I wish to object to the development proposal (09_0166 - Residential subdivision) by Metricon on the following grounds:

FIGURE 1

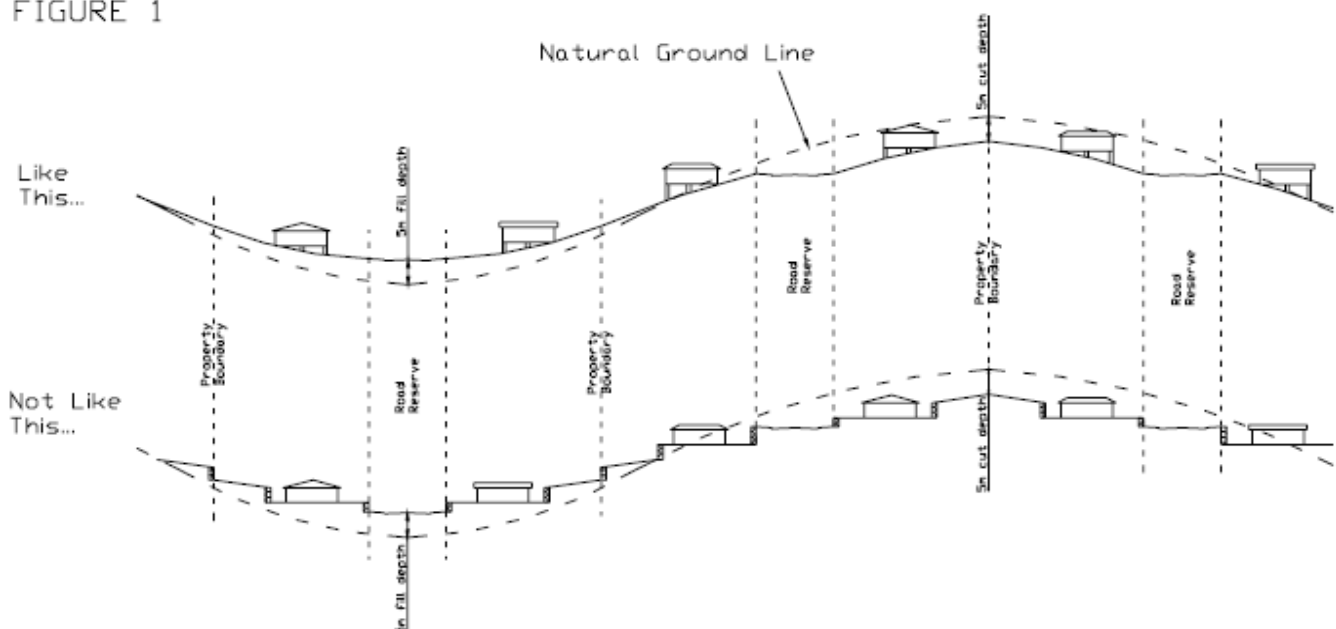
LVO is also dismissive of the impact on the Scenic Amenity of the proposed development on the residents of the adjoining rural living estate. As stated before, the proposed development is in a natural amphitheatre with the existing residents all looking across the proposed subdivision. In paragraph 44 LVO states that "the development seeks to maintain the topographical qualities of the site by limiting alteration of the landform". However, engineering plans show a highly altered topography that requires extensive filling (13 metres in some areas) and cutting; landforming requiring extensive terracing and retaining walls up to 6 metres in height. ***(Landforming that is also in contravention to Tweed Shire Council DCP No. 16 Site regrading Acceptance Criteria Development Design Specification –D6***

By understating the scenic impact of the massive landforming and retaining walls, LVO is simply delivering an assessment that the developers require to avoid the scrutiny of State Planning. From many properties in Parkes Lane, their view will consist of a highly altered landform with up to 15 terraced and retained building platforms with a backdrop of a 3 metre rock wall with a 2.4 metre acoustic wall on top bordering Fraser Drive.
